From: John Everly [<mailto:jeverly@pinnacleiowa.com>]
Sent: Monday, September 15, 2014 2:29 PM
To: Caldwell, Greg
Subject: RE: Additional documents for Calloway Farrowing, LLC

Attached are documents you requested for the Calloway Farrowing, LLC, permit application. Please find the following:

1 – Site placement map with distances to water sources and roads. The project manager told me there is no well on site but the site owner intends to drill a well that will be 300 feet from all structures.

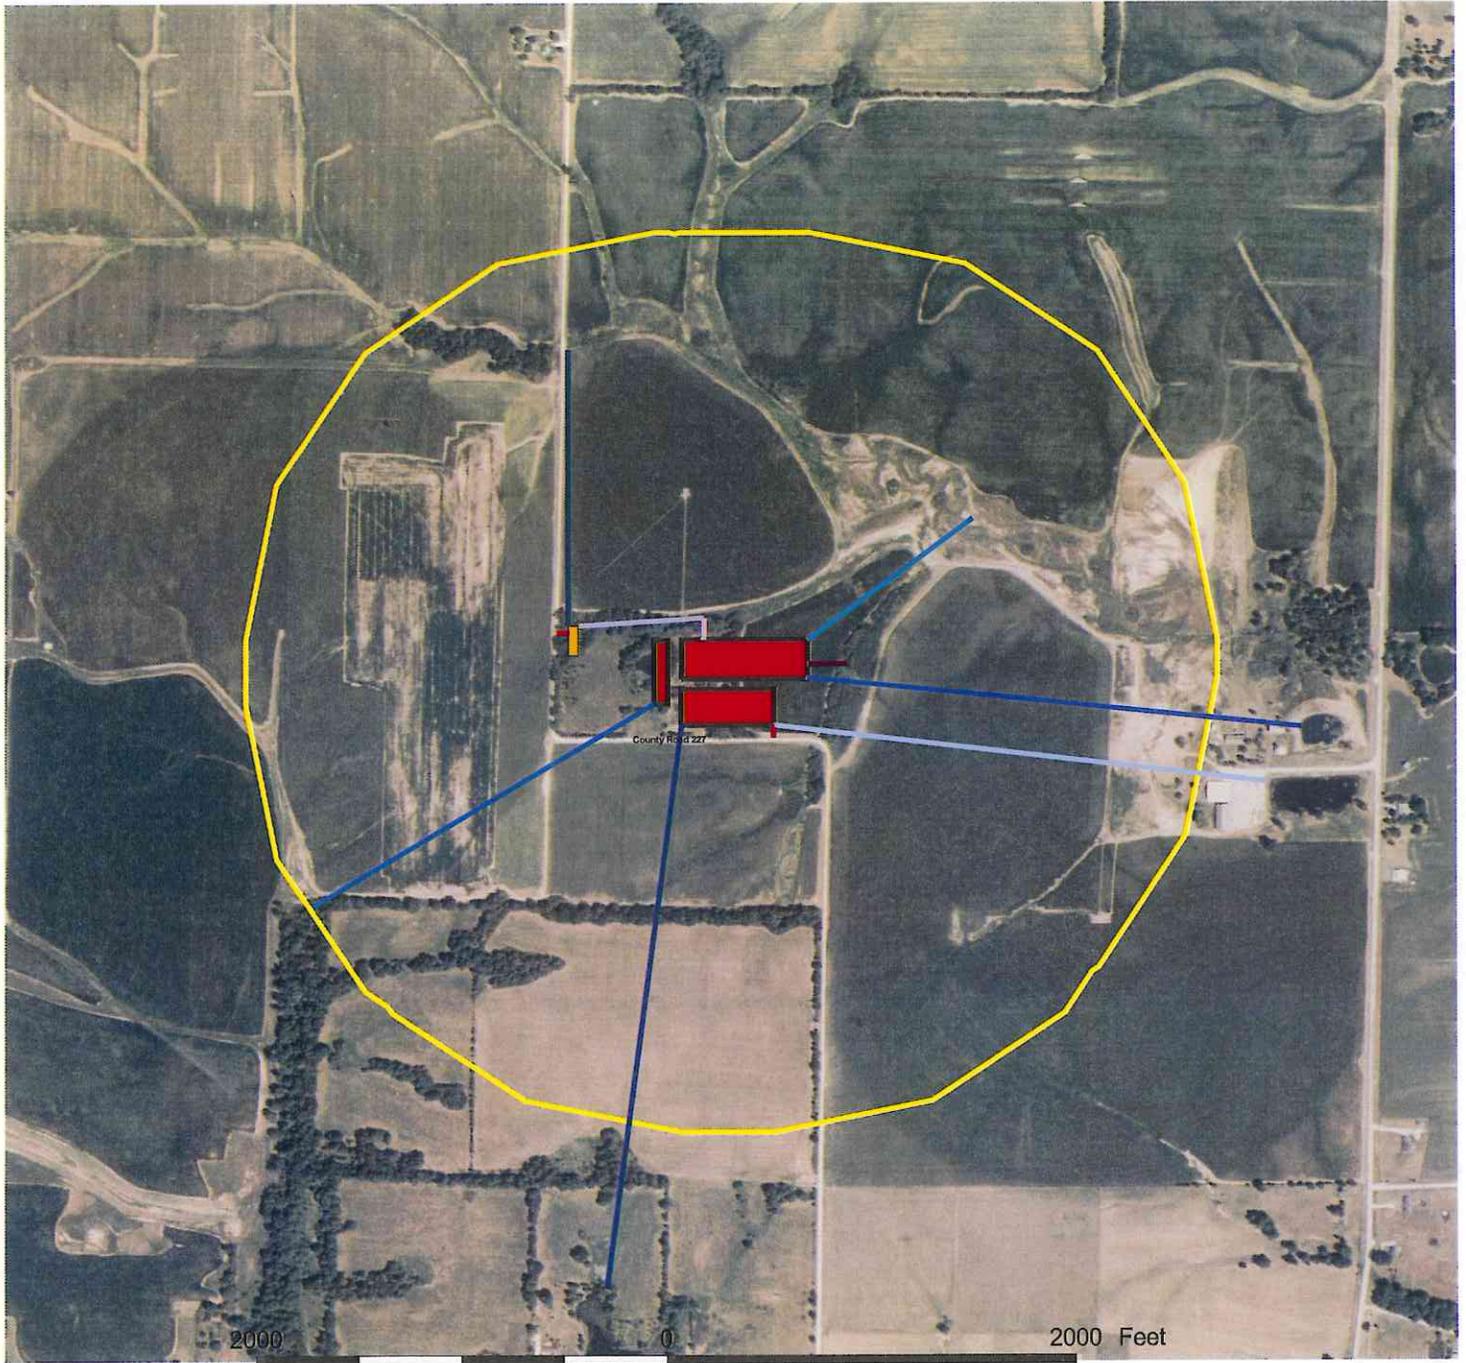
Attached is a site map with additional measurements. If I didn't interpret your notes correctly let me know. I am not sure if that bit to the north is actually a drainage, the aerials aren't definitive and you can see on Google Earth someone has left tracks where they turned around in it with a vehicle.

The contractor statement is good but I would like measurements from the building/composter to the drainages directly to the north and to the east of the site. See sticky notes on the attached map. Regulations state "100' to gaining streams (classified or unclassified; perennial or intermittent)".
